Video Products Technical Bulletin 30-2009-140

SUBJECT: REUSE ICs WHEN REPLACING BK BOARD

MODEL: ***BVM-D20F1A/1***
BVM-D20F1E
BVM-D20F1U

Figure 1

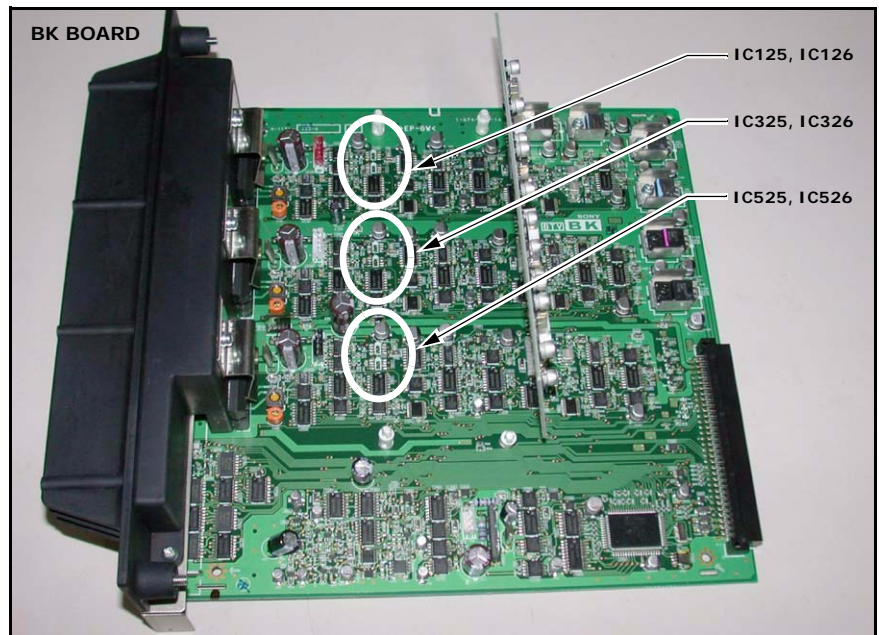
When replacing the BK board (A-1136-016-A), remove the following ICs from the former board and install them on the new board.

IC125, IC126

IC325, IC326

IC525, IC526

The new BK board does not contain the ICs, and the ICs are no longer available as service parts. (See Figure 1.)
